Ellen S. Hardgrove, AICP, Planning Consultant, Inc.

Date: November 18, 2021
To: Brett Solazzo, Administrative Assistant
From: Ellen Hardgrove, City Planning Consultant
XC: Sandy Riffle, Deputy City Clerk
Bea Meeks, City Clerk
Allen Lane, CPH Engineering, City Engineering Consultant
Jim Winter, CPH Engineering, City Landscape Architect Consultant
Re: Review of Mecatos Site Plan Submittal

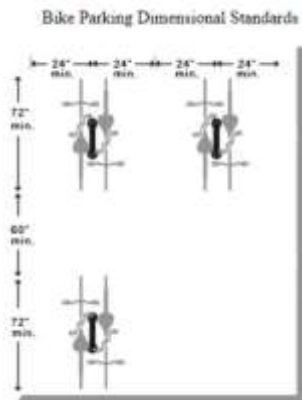
The location of the proposed street wall in the Hansel Avenue landscape buffer of the People Space is contrary to Code Section 134-474(c)(4)a, which states, the wall is required to be placed two feet from the drive aisle, including the width of a vertical curb, on the building side of the People Space, but not within the required buffer width, thus retaining the full width of the landscape buffer; which for the subject property would be 27 feet, plus the width of the wall.

The street wall is also not located per Code. It is required to be at the build line (25 feet from the front property line). It is proposed to be located at 21 feet from the property line south of the sidewalk and 8 feet from the front property line north of the sidewalk. A waiver for the width could be requested; however, the applicant must demonstrate that the reduction in width is illogical, impossible, impractical or unreasonable. Staff is recommending the drive aisles be changed to one-way, which eliminates the need for a 24 feet drive aisle width and provides the necessary width to meet the ECD standard (25 feet + 2 feet + width of wall).

Whereas it is reasonable to put the bicycle parking behind the street wall, the wall should then return to the required location. An alternative would be to move the bicycle parking to another location (see a potential site on the next page).

Action Needed: Redesign the buffer width and street wall location or request a waiver.

Recommended Action: relocate the bicycle parking and provide envisioned ECD design.

Drive-up Window Location and Queue Lane

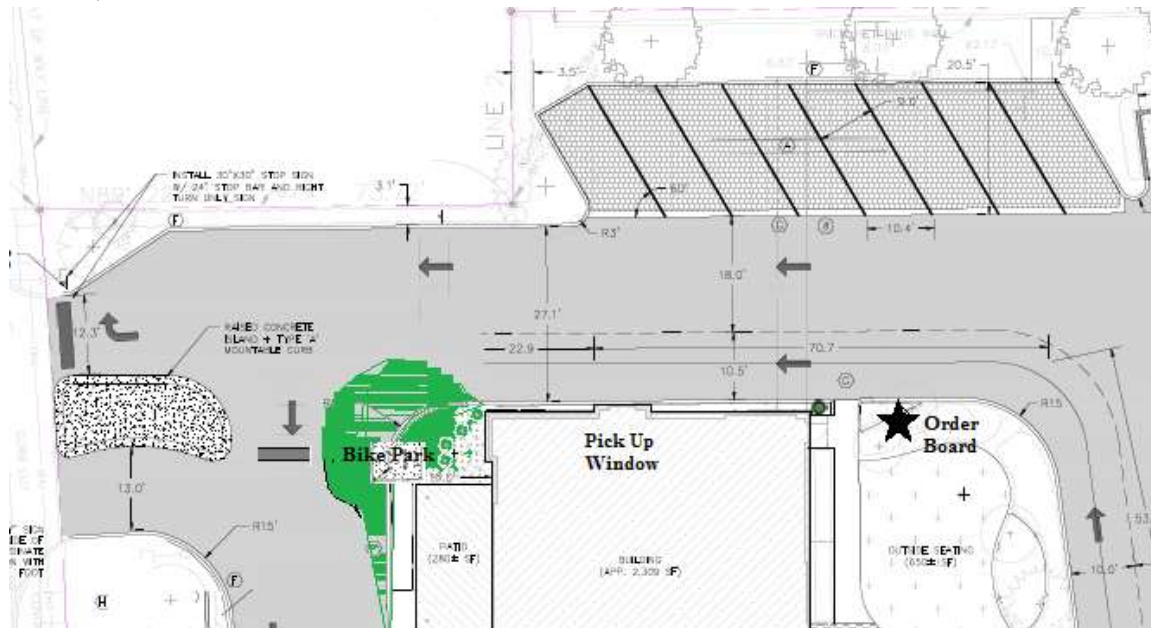
The applicant is requesting a waiver from Code Section 134-472(b), which requires drive-up windows to be designed on the rear of the building and to incorporate a drive up lane of a minimum of 120 feet in length as measured from the first stopping point; e.g., the order board. Due to using an existing building, the most practical location for a pick up window from the internal bakery floor plan perspective is on the north side. It would be impractical to locate the window in the rear. Staff can support this location with a condition for redesign of the front elevation with a faux wall or landscaping to “hide” the window from Hansel Avenue (see illustration).

Staff supports approval with the condition of screening the drive through lane/window from Hansel Avenue. The condition will help to,

Action Needed: Redesign to screen the drive through lane/window from Hansel Avenue.

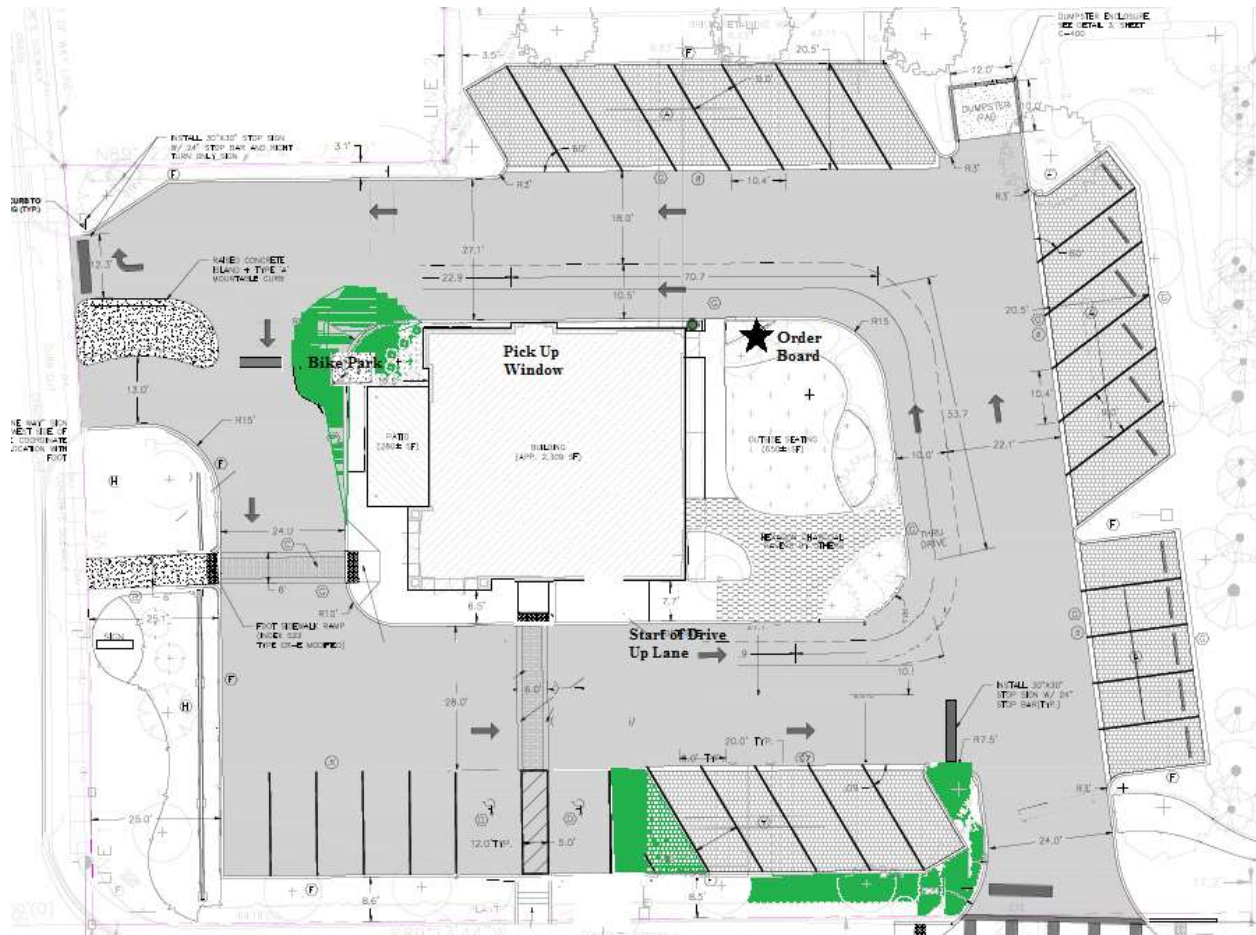
The second waiver related to the drive-up window is the queue length. The menu board/order location is not identified on the site plan, however is identified on the landscape plan. The proposed queue at the order board is 57 feet, only accommodating the ordering vehicle and one waiting. Code requires 120 feet, accommodating one at the order board and five waiting. The queue length can be increased by moving the order board to the west and using the northern 10.5 feet of part of the east/west drive aisle (after conversion to one-way) as illustrated on the next page. No parking spaces are lost in this alternative design.

In addition, an increase in queue length is recommended by moving the order/menu board five feet east of the sidewalk from the outdoor patio to the north parking area. Staff recommends provision of a cross walk and adding pavement striping to delineate the drive through lane staff recommends approval. This will help to serve the health, safety and welfare of the city.

Action Needed: Increase queue length, move the order/menu board five feet east of the sidewalk from the outdoor patio to the north parking area, provision of a cross walk, and adding pavement striping to delineate the drive through lane
